CITY OF FORT LAUDERDALE

CASE COMMENT REPORT

CASE NO. UDP-RS24005

CASE:	UDP-RS24005
MEETING DATE:	April 09, 2024
REQUEST:	Site Plan Level II Review: RAC Signage Request for Additional Wall Sign
APPLICANT:	Hector and Nancy Di Carlo
AGENT:	N/A
PROJECT NAME:	Di Carlo Building Signage
PROPERTY ADDRESS:	1321 S. Andrews Avenue
ZONING DISTRICT:	South Regional Activity Center-South Andrews east District (SRAC- SAe)
LAND USE:	South Regional Activity Center
COMMISSION DISTRICT:	4 - Warren Sturman
NEIGHBORHOOD ASSOCIATION:	Poinciana Park Civic Association
CASE PLANNER:	Tyler Laforme

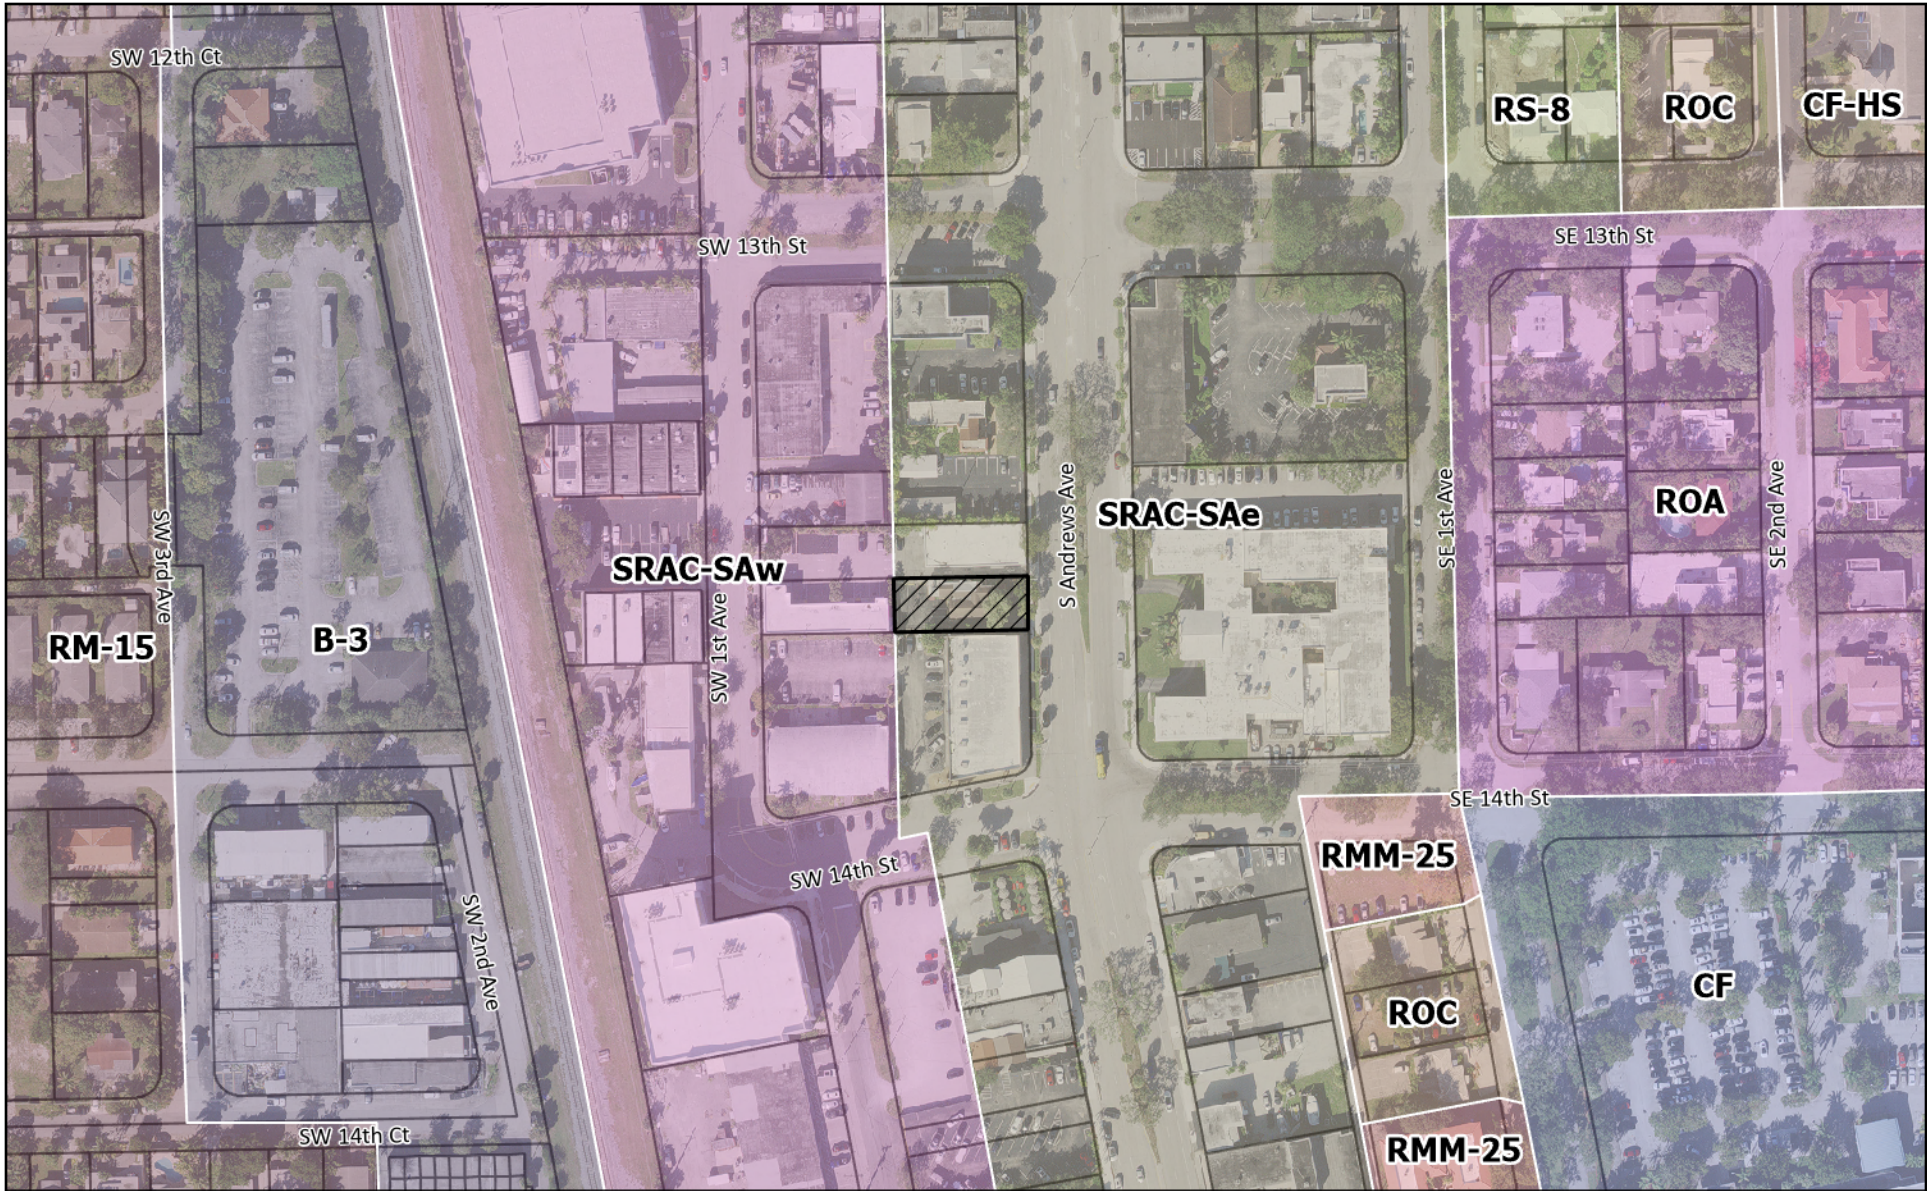
5. Based on existing conditions there is a freestanding sign that doesn't meet ULDR sign regulations, Section 47-22.3.D. According to staff research the sign location has been moved on the property closer to the street which does not meet ULDR requirements and therefore, the sign is noncompliant.
6. The applicant is requesting to add signage to the freestanding sign which would not be permitted. Applicant may request a sign design that is considered a ground sign and request the same location as part of this application so long as the sign size meets the requirements of ULDR, Section 47-22.3.D. Images below are examples of ground signs for visualization.
